TIMER CONNECTION

DESCRIPTION:

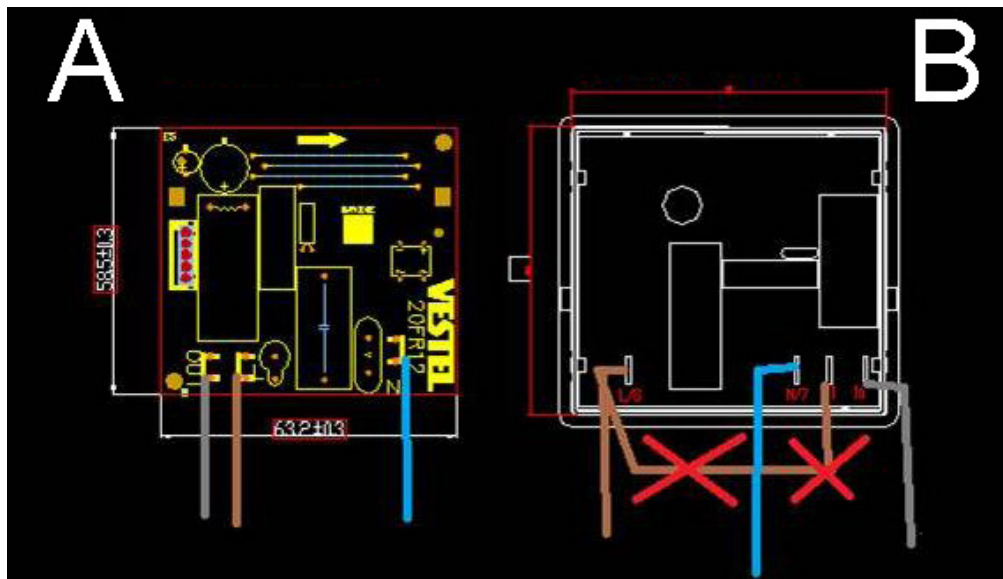
On new digital timers 5 cm brown cable used between L to 1 terminal is not necessary.
To use the new timer cut this cable.
See picture below.

- A- Cable connection on new timer.
- B- Cable connection on old timer.
